Burst CRC and FEC block CRC for 16m uplink and downlink data channel

IEEE C802.16m-08/1386

Re : TGM SDD: Other (Reply to Call for comments (IEEE 80216m-08/040) on SDD (IEEE 80216m-08/003r5)

To discuss and adopt the proposed text in the revision of the 802.16m SDD

Figure 43 Channel coding block diagram

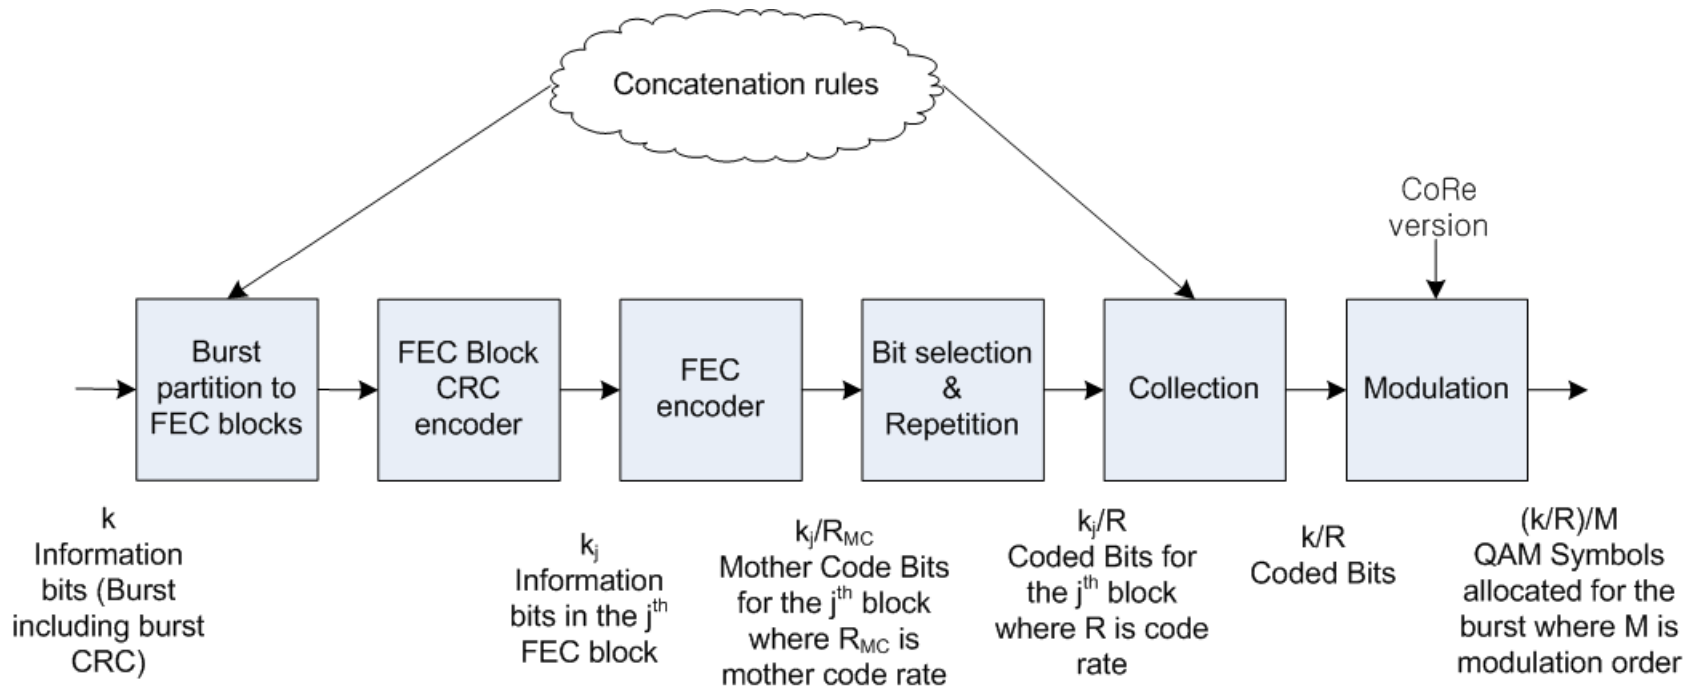
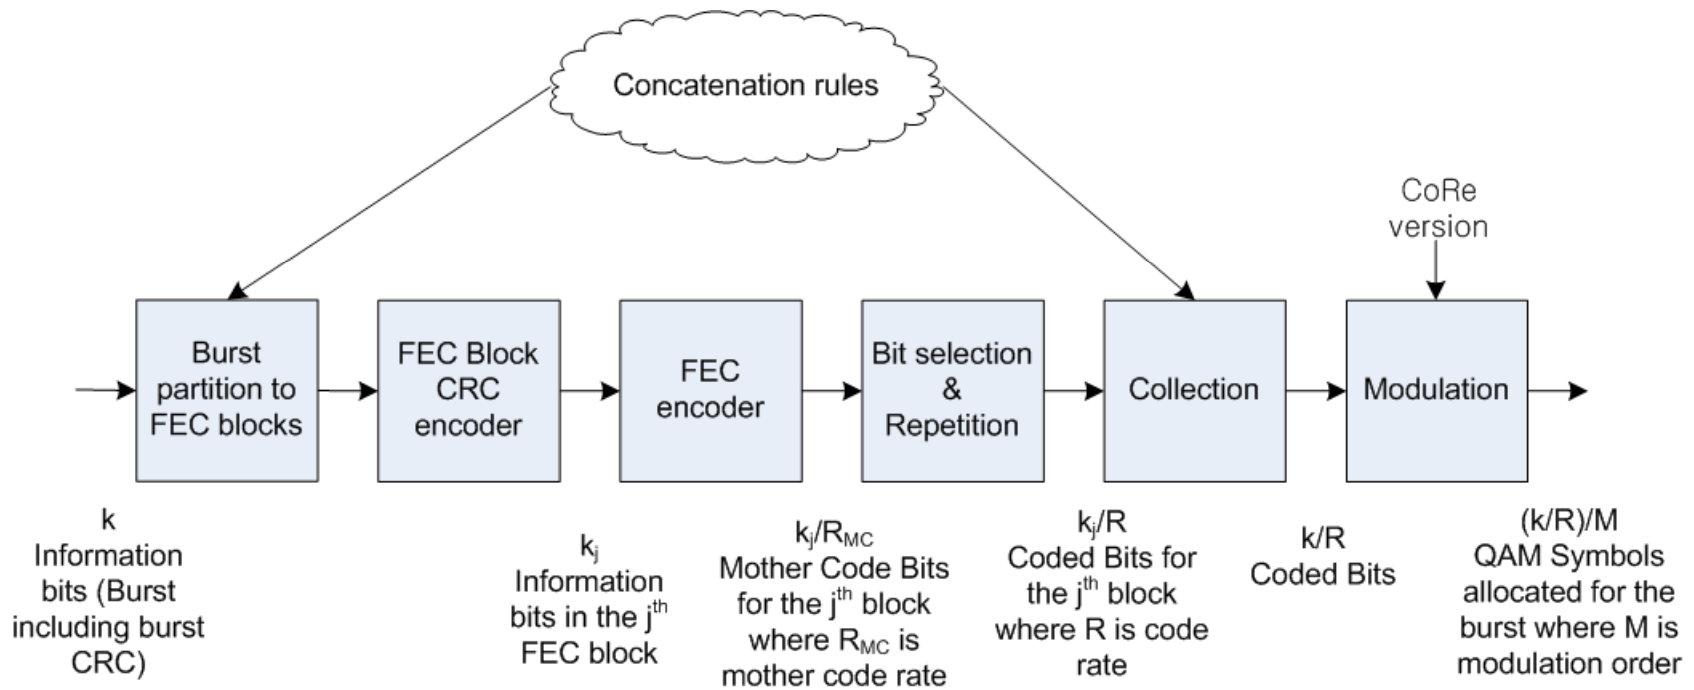
- Add FEC block CRC per FEC block in addition to Burst CRC
 - 16-bit FEC block CRC
 - 24-bit burst CRC

- Complexity reduction and power saving
 - FEC block CRC checksum can be used as stopping criteria for turbo decoding
 - Receiver can stop decoding for the whole burst once an FEC block is in error

- Page 102, line 15,
 - Replace Figure 43 by the following figure:

- Page 102, at the beginning of line 18,
 - Add “A 24-bit burst CRC is appended to a burst before the burst is further processed by burst partition. The generator polynomial of the burst CRC is $g_{\text{burst}}(x) = x^{24} + x^{23} + x^{18} + x^{17} + x^{14} + x^{11} + x^{10} + x^7 + x^6 + x^5 + x^4 + x^3 + x + 1$. The burst CRC is calculated based on all the bits in the burst.”

- Page 102, line 19, between “... is encoded separately.” and “The maximum FEC block ...”
 - Insert “If a burst is partitioned into more than one FEC blocks, a 16-bit FEC block CRC is appended to each FEC block before the FEC encoding. The generator polynomial of the FEC block CRC is $g_{\text{block}}(x) = x^{16} + x^{12} + x^5 + 1$. The FEC block CRC of an FEC block is calculated based on all the bits in that FEC block.”

- Page 102, line 21-22,
 - Delete the sentence “Error detection is provided at the end of the burst by appending a Cyclic Redundancy Check (CRC).”
